Contract #: 04-0120F4Cty: SF/ALA Rte: 80 PM: 13.2/13.9File #: 69.25B**QUALITY ASSURANCE -- NON-CONFORMANCE REPORT****Location:** Changxing Island, Shanghai, P.R. China**Report No:** NCR-000635**Prime Contractor:** American Bridge/Fluor Enterprises, a JV**Date:** 16-Jan-2010**Submitting Contractor:** Zhenhua Port Machinery Company, Ltd (ZPMC), Changxing Island**NCR #:** ZPMC-0608**Type of problem:**

Job Name: SAS Superstructure
Document No: 05.03.06-000595

Reference Description: Free hand thermal cutting without Engineer's Approval/ Tower/ Strut

Reference Description: Free hand thermal cutting on tower strut without Engineer's approval, South Tower Side

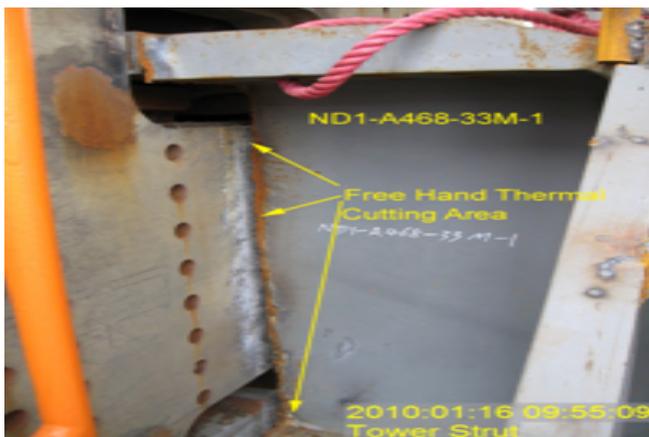
During the random Quality Assurance(QA) in process verification of Tower strut, this QA Inspector observed the following issues:

- Free hand thermal cutting were carried out on edges of the strut plate towards South Tower side without Engineer's approval.
- The strut is identified as ND1-A468-33M-1 at elevation level 33M.
- The thermal cut area is measured approximately 1010 mm.
- The material is designated as Seismic Performance Critical Member (SPCM).
- The member is located at Tower assembly area (Jetty Area).

AWS D1.5 (02) Section 3.2.3: "Steel and weld metal may be thermally cut, provided a smooth and regular surface free from cracks and notches is secured, and provided that an accurate profile is secured by the use of a mechanical guide. Freehand thermal cutting shall be done only where approved by the Engineer."

Reference Description: Free hand thermal cutting on tower strut without Engineer's approval, South Tower Side

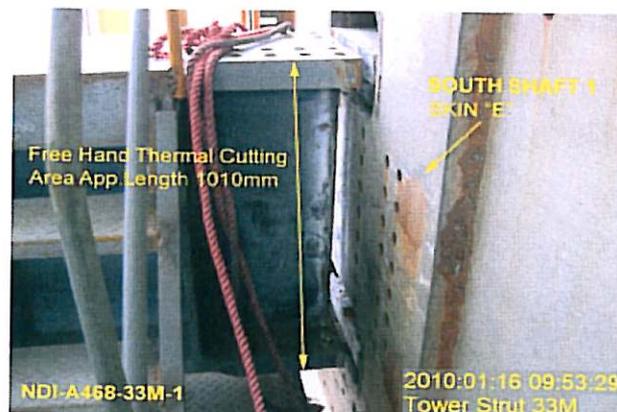
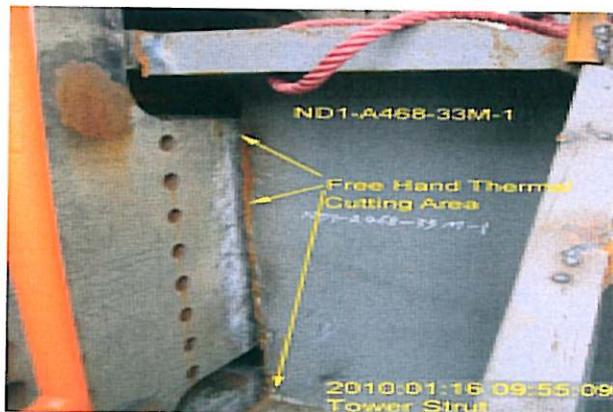
During the random Quality Assurance(QA) in process verification of Tower strut, this QA Inspector observed the following issues:

- Free hand thermal cutting were carried out on edges of the strut plate towards South Tower side without Engineer's approval.
- The strut is identified as ND1-A468-33M-1 at elevation level 33M.
- The thermal cut area is measured approximately 1010 mm.
- The material is designated as Seismic Performance Critical Member (SPCM).
- The member is located at Tower assembly area (Jetty Area).

AWS D1.5 (02) Section 3.2.3: "Steel and weld metal may be thermally cut, provided a smooth and regular surface free from cracks and notches is secured, and provided that an accurate profile is secured by the use of a mechanical guide. Freehand thermal cutting shall be done only where approved by the Engineer."

Reference Description: Free hand thermal cutting on tower strut without Engineer's approval, South Tower Side

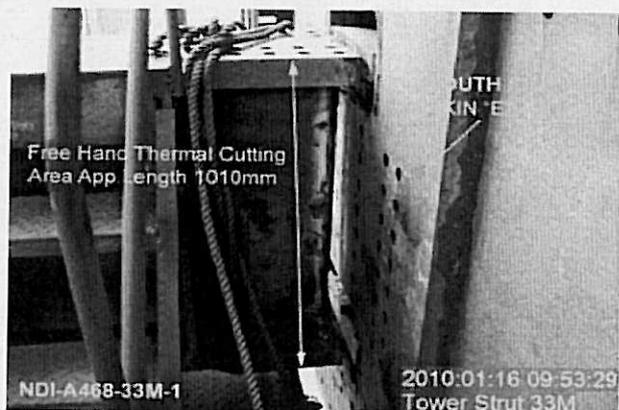
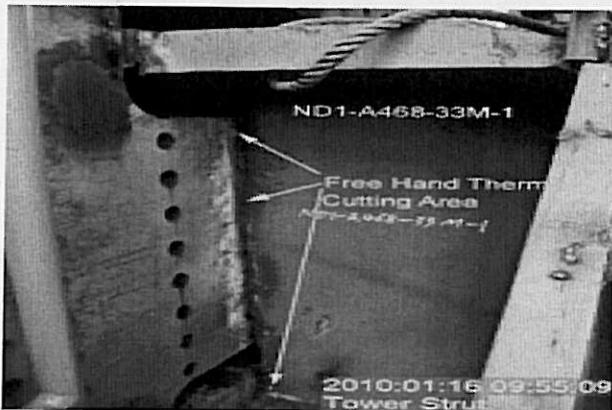
During the random Quality Assurance(QA) in process verification of Tower strut, this QA Inspector observed the following issues:

- Free hand thermal cutting were carried out on edges of the strut plate towards South Tower side without Engineer's approval.
- The strut is identified as ND1-A468-33M-1 at elevation level 33M.
- The thermal cut area is measured approximately 1010 mm.
- The material is designated as Seismic Performance Critical Member (SPCM).
- The member is located at Tower assembly area (Jetty Area).

AWS D1.5 (02) Section 3.2.3: "Steel and weld metal may be thermally cut, provided a smooth and regular surface free from cracks and notches is secured, and provided that an accurate profile is secured by the use of a mechanical guide. Freehand thermal cutting shall be done only where approved by the Engineer."

焊缝返修位置示意图:
Draft of Welding Discontinuity:

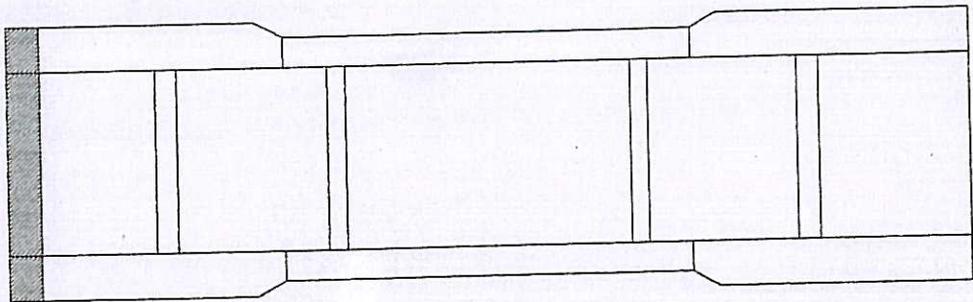
焊缝缺陷描述:
Description of welding discontinuity:
 南塔E面33米联系梁总拼时由于塔柱之间干涉, 对联系梁端部进行修割, 割除部分约5-13毫米, 现在要求堆焊处理, 堆焊长度约5-13毫米。具体如下图所示:
 During splice South tower Skin E 33m strut plate and tower, trim strut plate 5-13mm, and needed to build up 5-13mm, the detail sees the following draft.

注: 阴影部分为堆焊区域
 Remark: repair area in shadow.

1. QC/CWI shall monitor and direct all grinding and welding during the repair procedure.
2. Grind the repair area smooth
3. Verify that no defects are present by VT and MT prior to welding
4. Apply backing bar and weld
5. Preheat and maintain interpass temperature control according to the approved WPS
6. QC shall ensure all slag has been removed prior the deposition of next pass
7. The weld size should be greater than theoretical size by about 2 to 3mm.
8. Remove backing bar and grind the weld area smooth after buttering
9. Perform VT, MT and UT inspection on the repaired area
